To	Noureen Wajid (Town Planner – Berrigan Shire Council)
From	Chris Greenland (Ratio)
Regarding	Response to Request for Further Information Letter
Date	10/01/2025
Reference Number	48-25-DA-DM
Document Number	21804T-LET01-F01

1. Background and Introduction

Ratio has prepared this letter in order to review, clarify and respond to transport engineering matters raised by Berrigan Shire Council (Council) pursuant to the proposed residential subdivision (Application No. 48-25-DA-DM) of subject land located at 32 Burma Road, Tocumwal.

Figure 1: Post Development Traffic Volumes

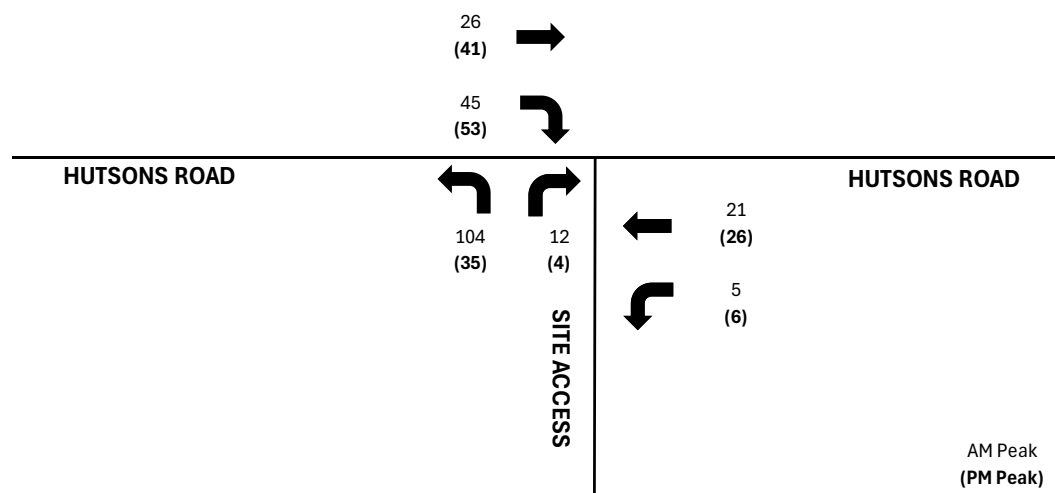
Following review of the proposal, Council outlined their comments via a Request for Further Information (RFI) letter, dated 19 December 2024. Within the abovementioned letter, Council requested “*an updated TMP to include statistics for the entire development (not just the first stage of it), and potential traffic generation from the development*”.

In line with the original traffic report, it is estimated that **90% of the site-generated traffic** will travel to/from the west of the site, toward Tocumwal, with **10% traveling to/from the east**. This distribution reflects the regional context of the site, with the township of Tocumwal serving as the primary destination for employment, education, and essential services.

Figure 1 has been prepared detailing the anticipated post-development traffic volumes at the site access intersection. This figure incorporates background traffic volumes on Hutsons Road, as determined through turning movement counts undertaken by Spotto Consulting on Wednesday, 19 July 2023, for a prior application scheme for the site.

Consistent with the original TIA, all development traffic has been routed through the site access intersection to ensure a conservative assessment of post-development conditions. As shown in the proposed site layout, standard dwellings do not have access to the internal road network. Consequently, traffic generated by these dwellings will primarily utilise Hutsons Road and Burma Road.
